RESUBMIT APPROVED AS NOTED
BY C. CARLSON DATE 07-27-2012

PROJECT: VT RT 9, BRIDGE NO. 11
TOWN OF WOODFORD, VT
OVER WALDOMSAC RIVER

TITLE: GIRDER 106G1

REFERENCE: PROJECT NO. ER BHF 010-1 (44)

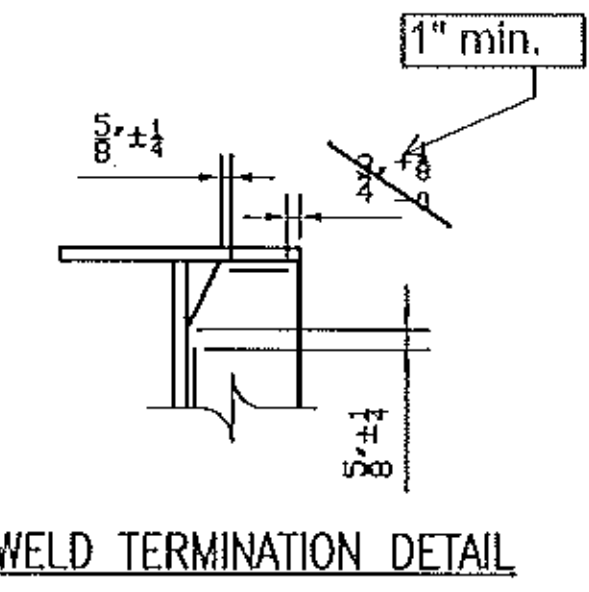
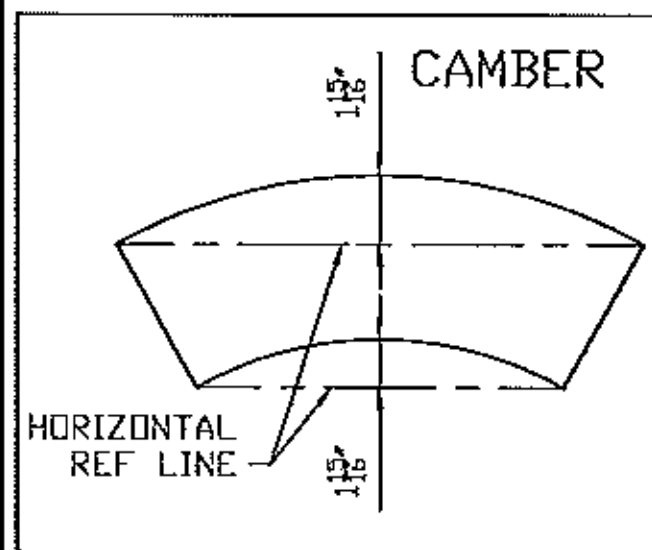
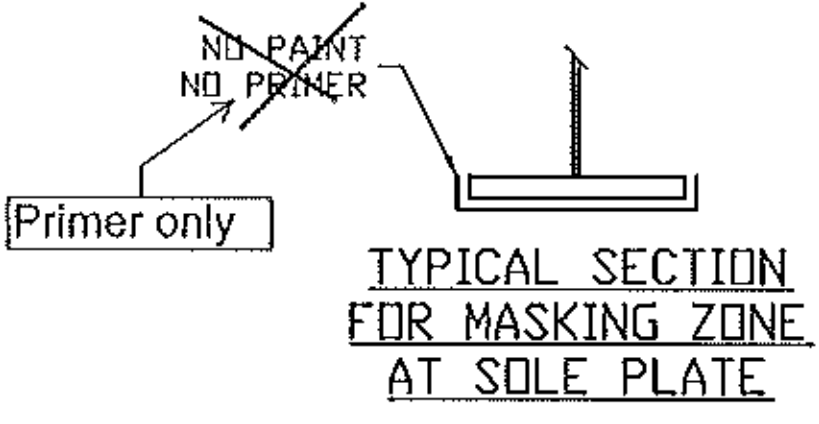
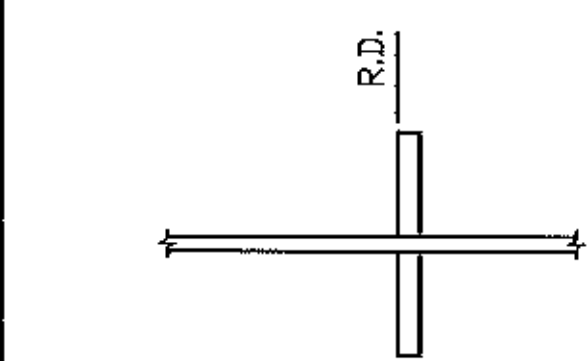
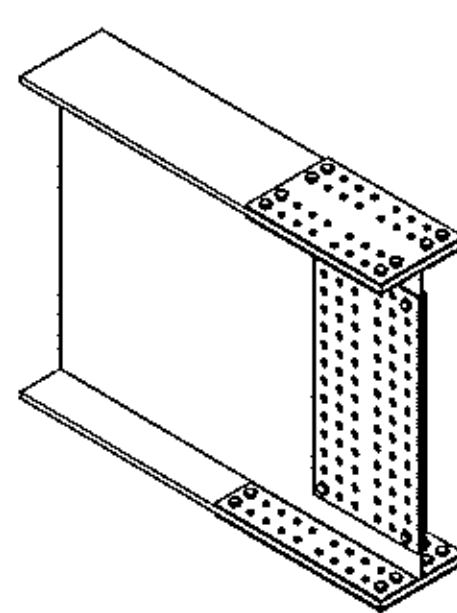
Is there room for WPS S-1001 with dart welder? There is only 5 3/4\" between the two plates Typ. all girders.

THE FIELD SPLICE PLATES MUST NOT EXCEED THE END OF GIRDER

See standard specification 506.24(a)(9), no payment will be made for bolts, nuts, washers, they are considered to be incidental
